**DEH APN FILE TARGET SHEET
ARCHIVE RECORD**
Pre-KIVA & Existing APN Records

Document Type: Legacy Septic System Documents

APN(s) 171-161-15

San Diego County Environmental Health Dept.
To whom it may concern:
Control # L 72777 R
Site: 412 Taylor Street, Vista, CA 92084

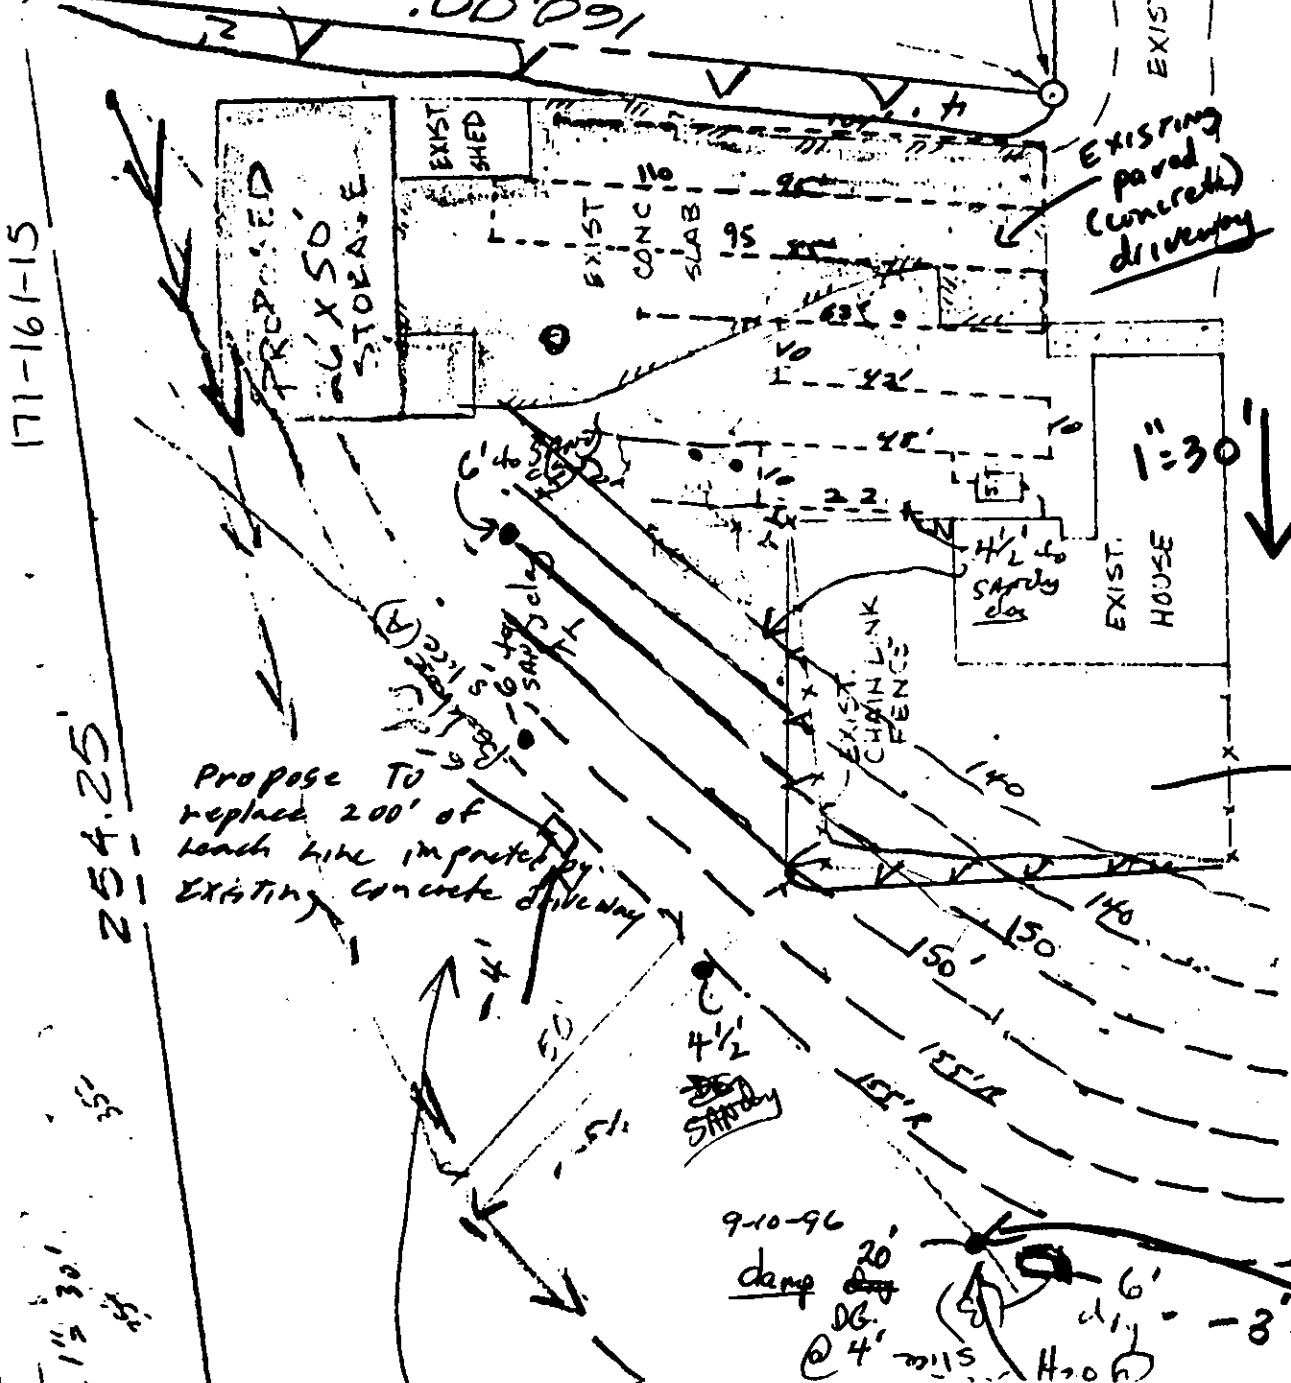
2 - That concrete driveway is not permitted or approved - but will not be removed as sufficient area is available for New primary + reserve areas.

3 - owner will pursue sewer easement ~ 100' to east across neighbors property.

4 - Fill area to North of House to be removed as needed to install new Leach lines.

Available - 1062' - Fill to be removed if area needed -
 Need 530' primary + 530' Reserve -
 (347' impacted by (183' meets code) existing concrete driveway)

Sewer - ~ 100' away - need to be accessed (total cost ~ 10,000) + need EPEment

Approved
 Department of Environmental Health
 Specialist
 Date 10-21-96
